U.S. Department of Energy
Office of River Protection

12-WTP-0395

**TRANSMITTAL OF DEFENSE NUCLEAR FACILITIES SAFETY BOARD (DNFSB)
RECOMMENDATION 2010-2 IMPLEMENTATION PLAN (IP) DELIVERABLE 5.5.3.1**

Subject: ONE SYSTEM TECHNICAL TEAM RESPONSE TO REVIEW OF ONE SYSTEM INITIAL GAP ANALYSIS BETWEEN WASTE TREATMENT PLANT WASTE ACCEPTANCE CRITERIA AND TANK FARM SAMPLING AND TRANSFER CAPABILITY (ERT-21)

Figure 2-1. Elements of Feed Uncertainties.

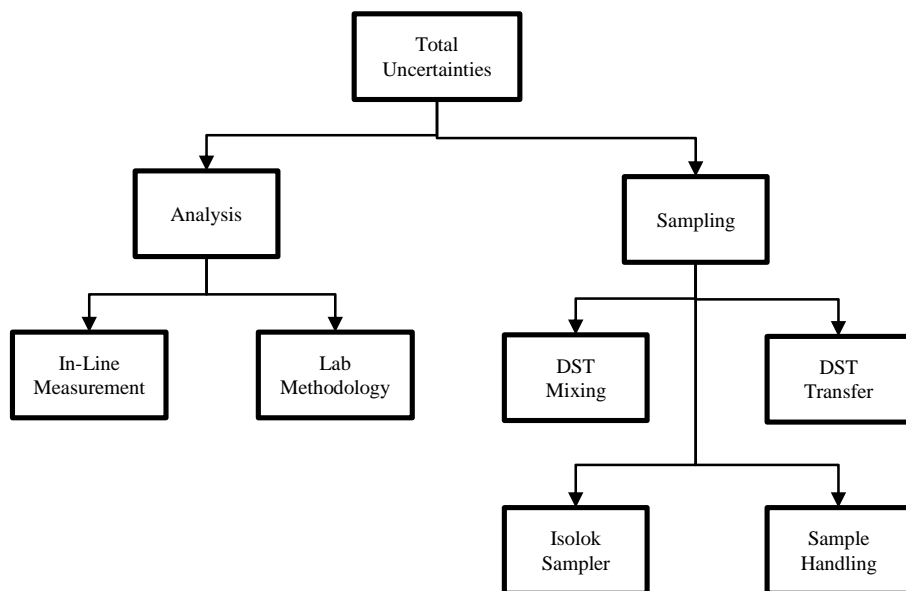
26	EKH	E	Page 19, Section 2.1, fourth paragraph, second sentence: Recommend “These RSDs are determined by Subject Matter Experts ...”.	Accept.
27	EKH	E	Page 19, Figure 2-1: This is a little confusing. I would have expected two branches coming off total uncertainties, DST Mixing, and DST transfer; one being In-line measurements and the other being Isolok sampler, sample handling, and lab methodology.	DST mixing and DST transfer uncertainties are binned under Sampling to account for their potential impact (spatial and temporal respectively) on the pre-transfer samples. Everything is relative to the waste acceptance decision so focus is on the samples and analysis.
28	EKH	M	Page 19, Section 2.1, fifth paragraph, last sentence: This validated output uses an average solids density of 3.0 g/cm³. This is above the 2.9 g/cm³ wac limit and definitely way above the 2.18 g/cm³ average limit specified in Table 3-2. This would indicate you’ve got problems off the bat! Address this difference.	Agree. As stated in Table 3-2, this parameter (2.18 g/ml) is not a “WAC” limit yet (i.e., not in ICD-19). However the apparent disconnect between the TOC planning basis (HTWOS) and the WTP design basis could have potential production impact. This is identified as an “Open Item” to reconcile the disconnect.

Figure 6-15. AY-102 Tank Waste Temperature Prediction.¹

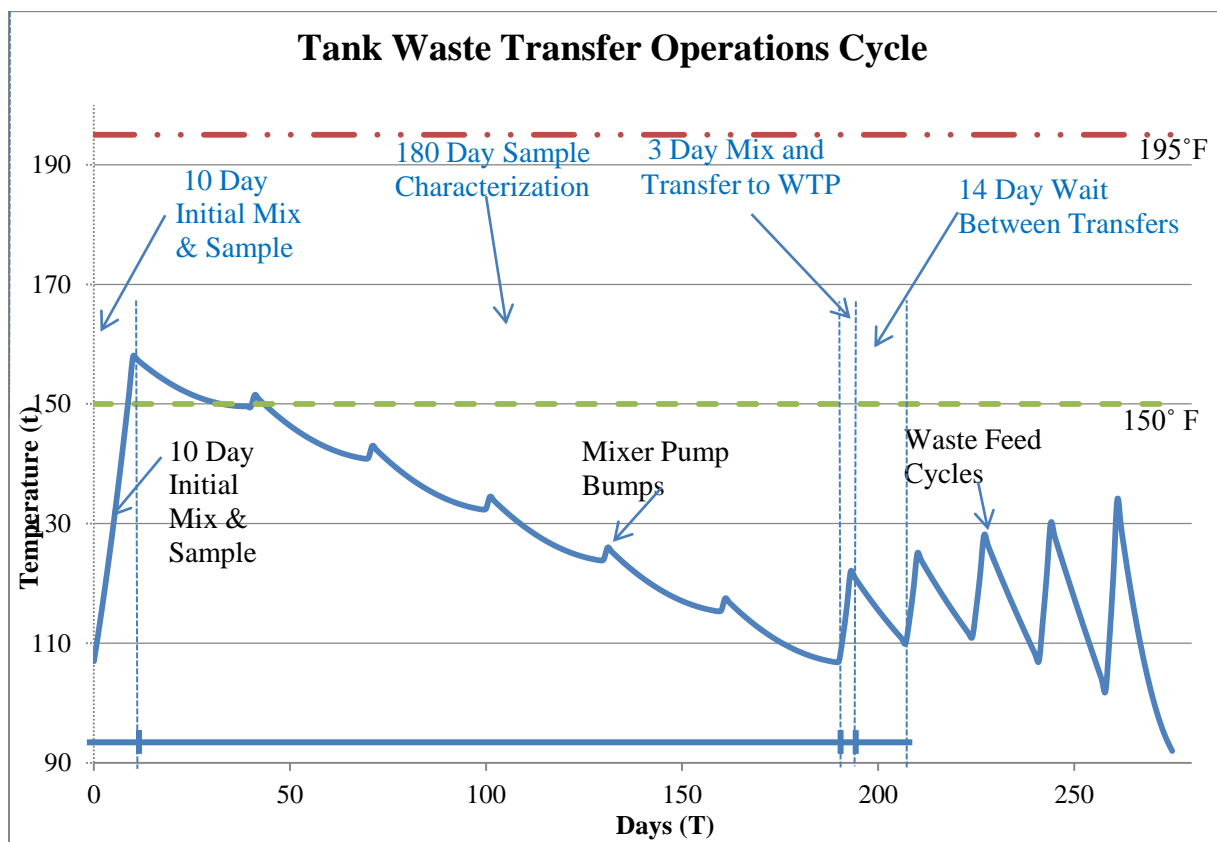
168	RVC	O	Figure 6-17: It is not clear what the various horizontal lines mean.	The two horizontal dashed lines are temperature limits at 195 and 150 °F.
169	RVC	O	Appendix A: Equations without some explanation or references to guide the reader are not always useful.	Reference provided at the end of the equations (moved to up front).
170	EKH	E	The use of the word “consistency” should be referred to as that of a rheology property. Check your document in the use of this word (pp. 28, Figure 4-1, 4-2, pp 43)	<i>Accept. Changed to trend where it is not referring to a rheological property.</i>
